SUBJECT: NRC Requested Documents

TEMPORARY CHANGE NOTICE

Procedure No. SO23-I-4.36 Revision No. 0 TCN No. 1 ~~SO23-1-4.36~~ ^{1 OF 104}
Procedure Title INSPECTION AND ADJUSTMENT OF UNDER VOLTAGE TRIPPING DEVICE
Procedure Author _____ PAX _____ (If known, Writer) _____ PAX _____

TO MEET REQUIREMENTS OF IE 79-09

ATTACHMENT 8.5
~~EXHIBIT D~~

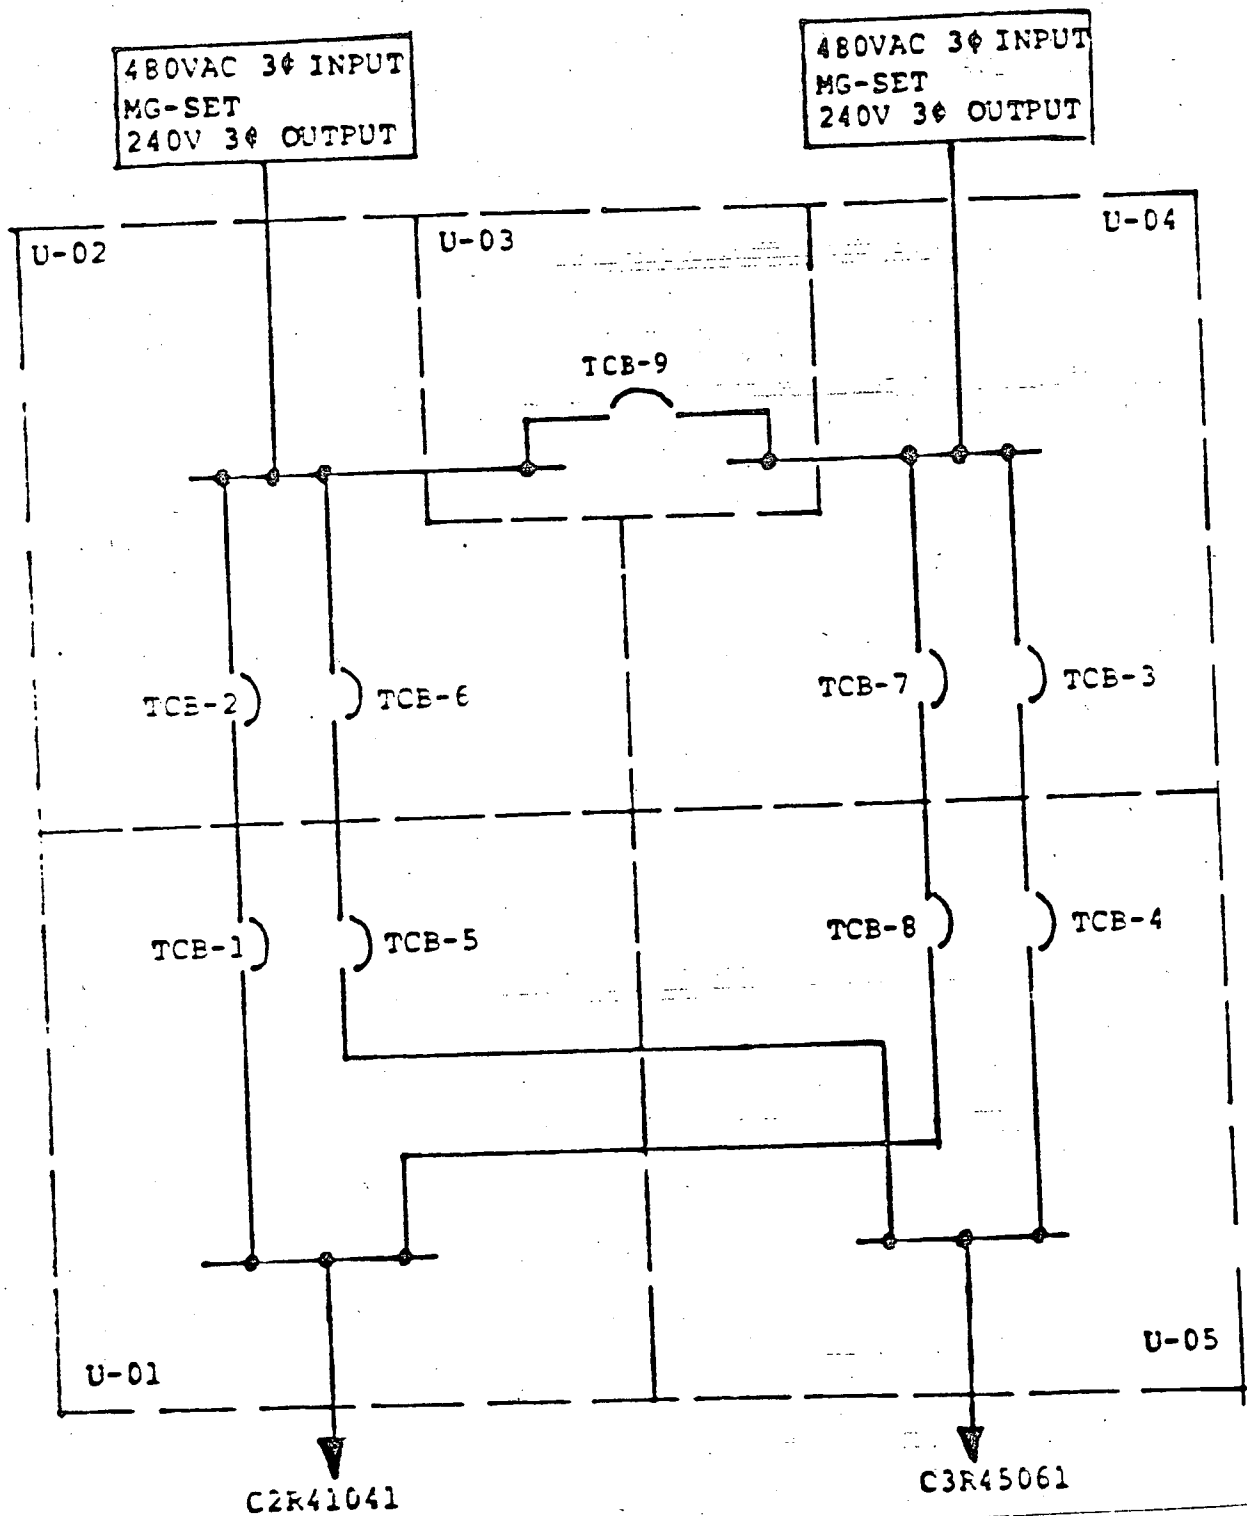
- 6.6.5 Trip Latch Check - TCB-5 (EXHIBIT D) ATTACHMENT 8.5
- 6.6.5.1 Preparation
- 6.6.5.1.1 Verify 2B1509 and 2B1606 "OPEN" (EXHIBIT E). Record on MDRF, EXHIBIT F.*
